U. S. Nuclear Regulatory Commission  
ATTN: Document Control Desk  
Washington, DC 20555-0001Peach Bottom Atomic Power Station, Units 2 & 3  
Facility Operating License Nos. DPR-44 and DPR-56  
NRC Docket Nos. 50-277 and 50-278Subject: Supplement to the Request for License Amendments Related to Application of  
Alternative Source Term, dated July 14, 2003

**Supplement to License Amendment Request for  
"PBAPS Alternative Source Term Implementation"**

**Response to Request for Additional Information**

REQUEST FOR ADDITIONAL INFORMATION  
PEACH BOTTOM ATOMIC POWER STATION, UNITS 2 AND 3  
PROPOSED USE OF ALTERNATIVE SOURCE TERM (AST) METHODOLOGY

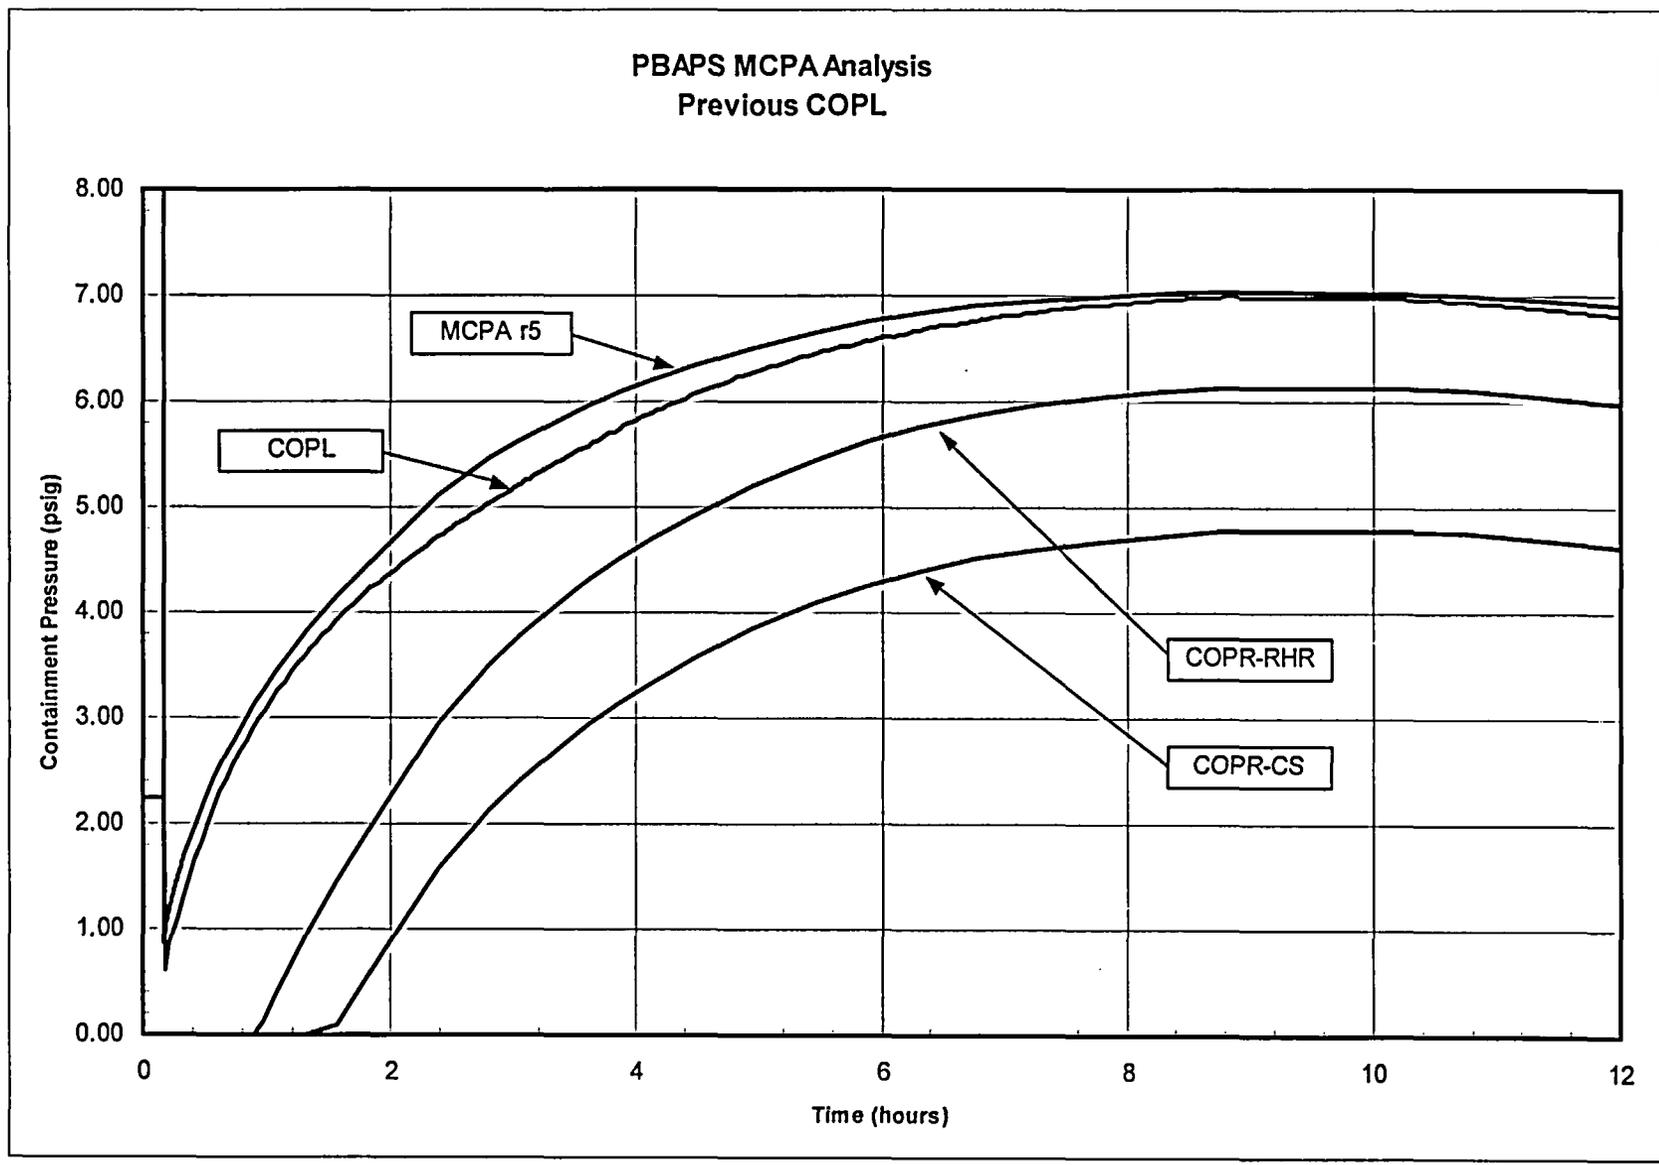
- a. Provide a justification for reducing this agreed to margin.
  - b. Provide a comparison of the COPL value to the COPR (containment overpressure required) value for the residual heat removal (RHR) and core spray pumps for the most limiting event(s), including the margin to the COPL value before and after the proposed change to the MCPA/COPL calculation.

- (a) Although the COPL line was derived using a 1 foot margin to the MCPA, it is our understanding that, like the original Peach Bottom FSAR containment overpressure limit line, the NRC SER has established the COPL line itself, "depicted on UFSAR Figure 5.2.16" as the limit, rather than the maintaining of a specified margin to the MCPA. With the COPL being a fixed line, the proposed AST changes would have reduced the MCPA margin to the previous COPL from 1 foot of head (7.41 - 6.99=0.42 psid) to essentially zero (7.04 - 6.99=0.05 psid). Consequently, a new COPL limit needs to be proposed.

If instead of COPL being a fixed line, maintaining a 1 foot of head margin to the MCPA were the case, adequate overpressure margin would still be available to satisfy the NPSH requirements of the RHR pump during the design basis LOCA. A 1 foot of head margin to the new MCPA would produce a peak COPL of 6.62psig (7.04 - 0.42=6.62 psig), which still provides another foot of margin to the peak COPR for RHR of 6.14 psig (6.62 - 6.14=0.48 psid).

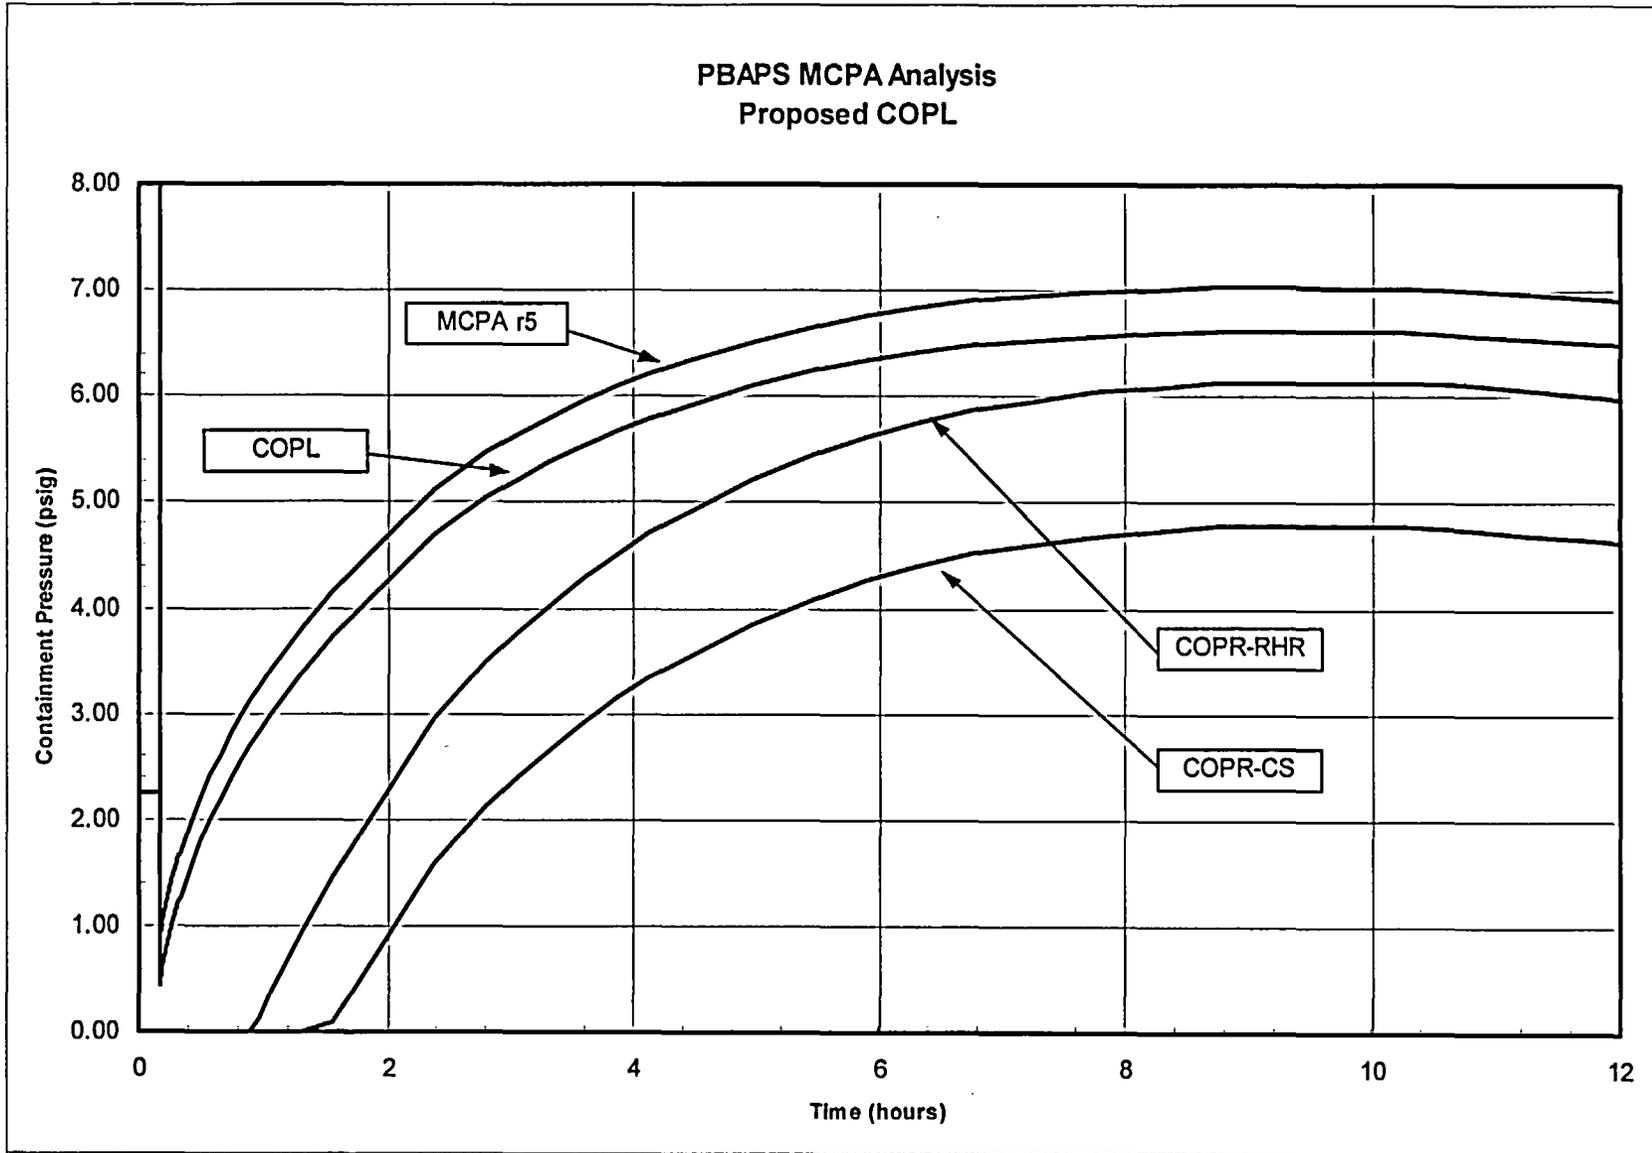
The COPL line that was proposed with the AST amendment request preserved the relative relationship between the COPR, COPL, and MCPA from the previous NRC review. With about a third of the available margin between MCPA and COPR being assigned to the COPL, the new proposed COPL line still maintains about a third of the available margin to the MCPA (0.69 foot, approx. 0.29 psid).

**FIGURE 1**

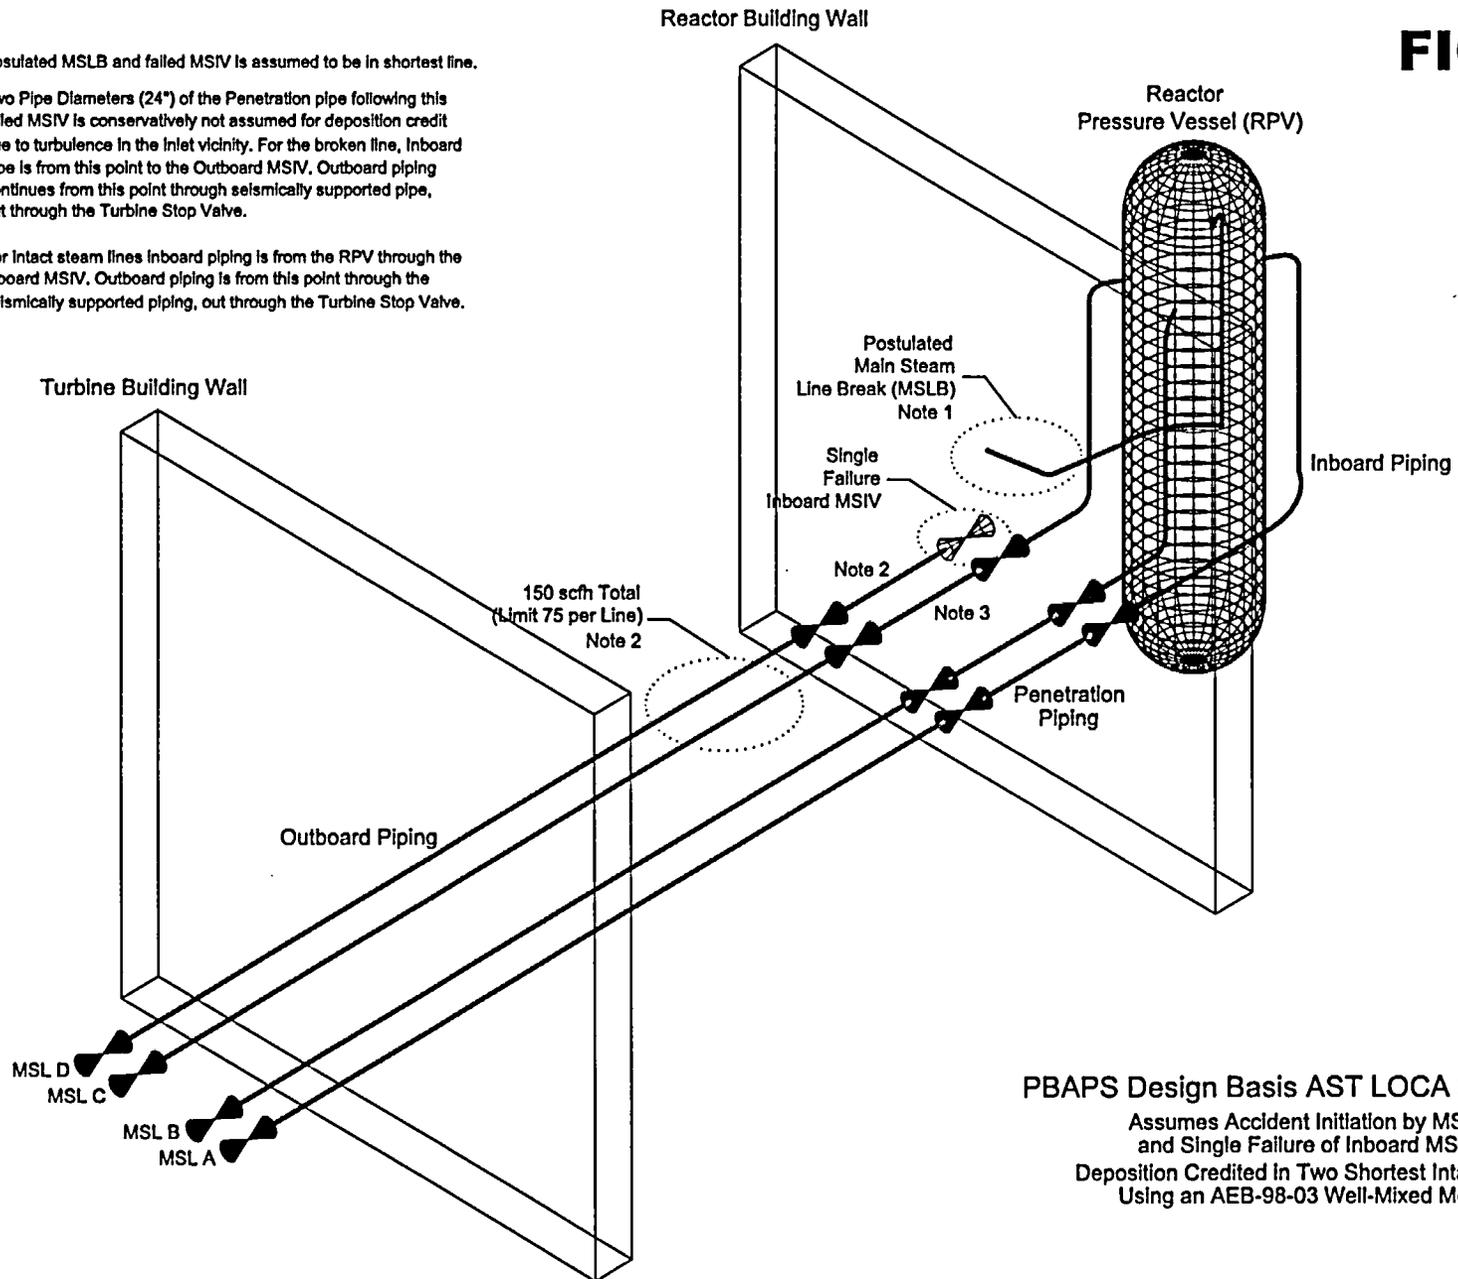
- a. A single-line sketch of the four main steamlines and the isolation valves. Annotate this sketch to identify each of the control volumes assumed by Exelon in the deposition model.

- d. Clarify if your analysis addresses a single failure of one of the MSIVs. Such a failure could change the control volume parameters that are input to the deposition model. Previous implementations of main steam deposition have been found acceptable only if the licensee had modeled a limiting single failure. Please explain why Exelon feels that such a limiting failure need not be considered if it is not considered.

Furthermore, since deposition in inboard MS piping is being credited, the design basis pipe break is assumed to be a steam line break inside containment in the vicinity of an inboard MSIV.

A single inboard MSIV failure is assumed on the broken line. The MSIV assumed to fail open is the one associated with the broken inboard line that produces the highest dose. To account for possible containment turbulence in the vicinity of the penetration piping, the first two pipe diameters in the penetration will not be credited.

Figure 1 in this attachment, shows a single-line sketch of the four main steam lines and the isolation valves. This figure shows control volumes and break locations.
